TRANS/WP.29/1010
16 April 2004

World Forum for Harmonization of Vehicle Regulations (WP.29)

SUPPLEMENT 3 TO REGULATION No.106

(Agricultural tyres)

Annex 10, the table., insert two new rows to read:

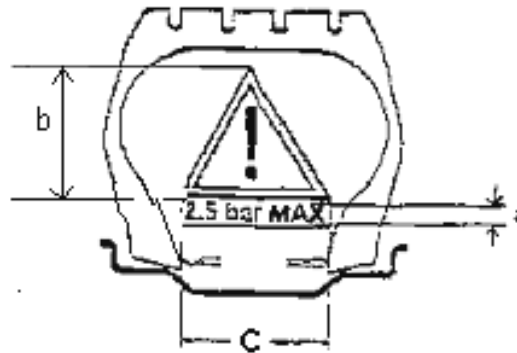
Classification code	Nomenclature
.....
I-6	Agricultural implement tyres : Smooth tread
LS-1	Logging and Forestry Service Tyres : regular tread
LS-2
LS-3
LS-4	Logging and Forestry Service Tyres : shallow tread
.....
